ADVISORY REPORT
FINDINGS, CONCLUSIONS, AND RECOMMENDATIONS

Date: April 7, 2015

File: WEBBER SHORT PLAT AND BUFFER MODIFICATION, FILE NO'S SUB14-01017 / SAR14-01018

12833 NE 90TH ST - TREE PLAN

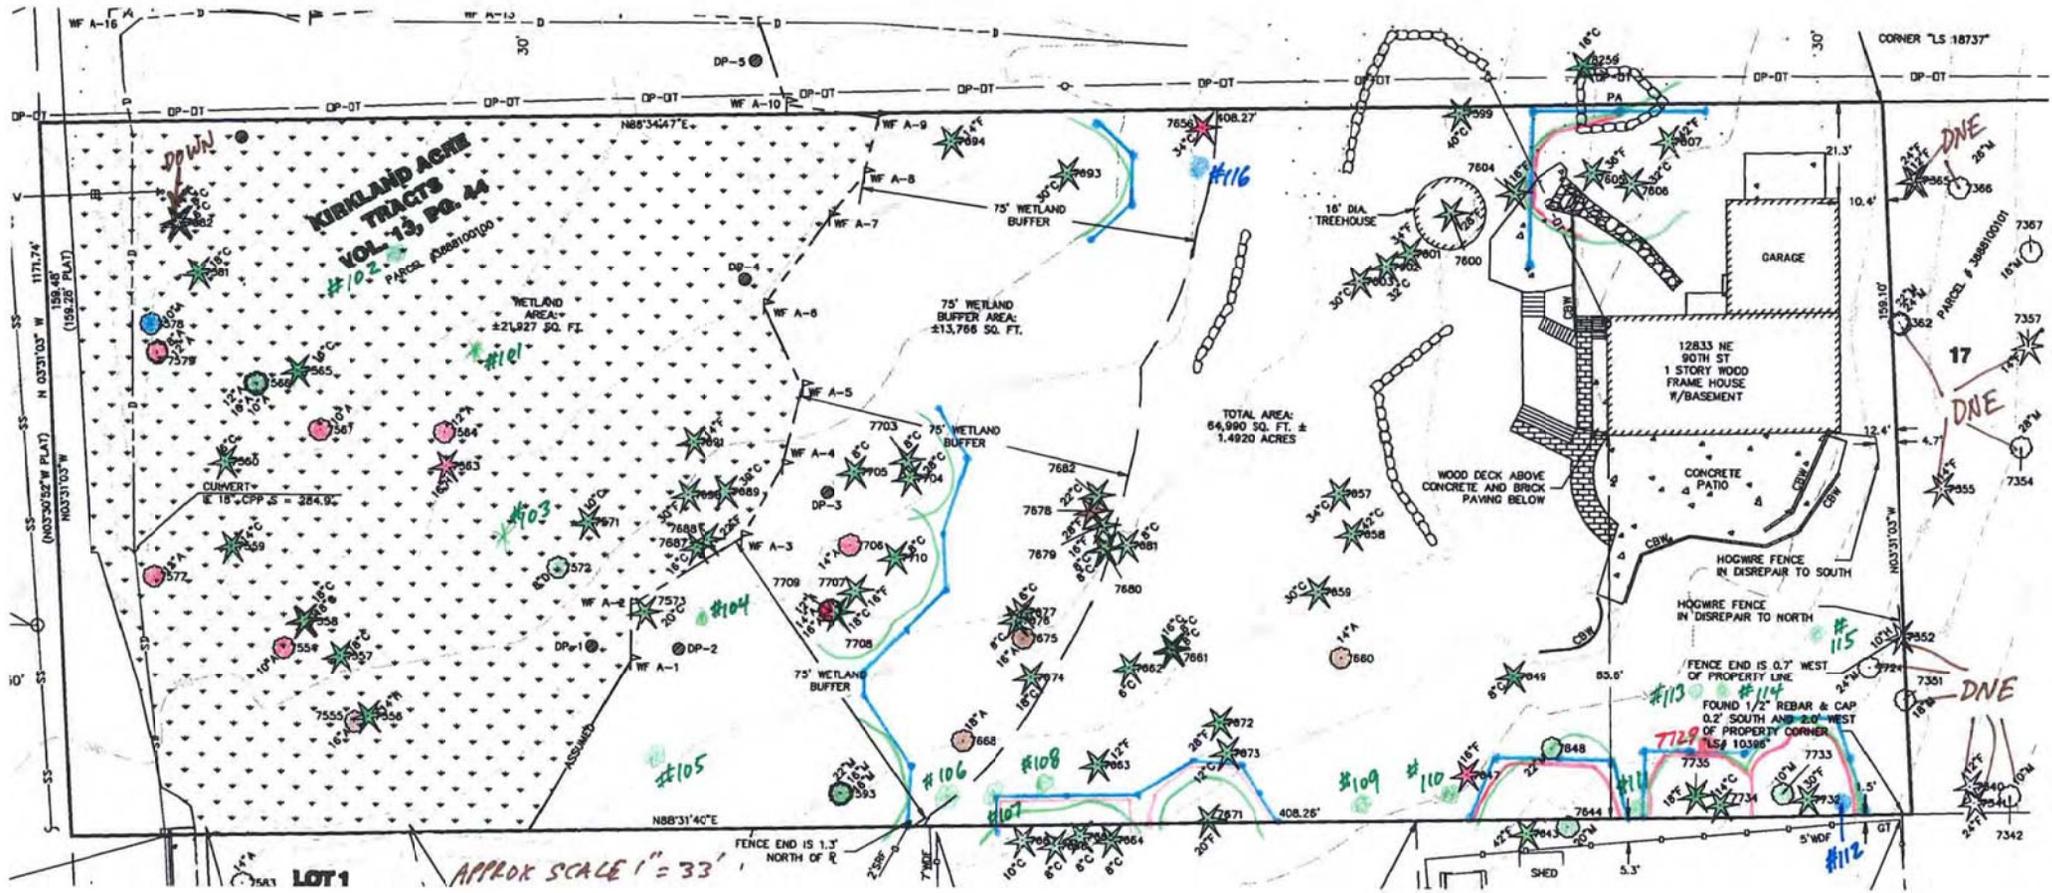
- Plans should be altered to move storm drainage systems level spreader installations outside of the limits of disturbance for trees to remain, specifically tree #7693, 7668 and 7593. **PCD NOTES: 7668 is not a high retention due to location; Trees #7668 and 7593 omitted from above chart (also not accounted for in chart, neither is 7593).**
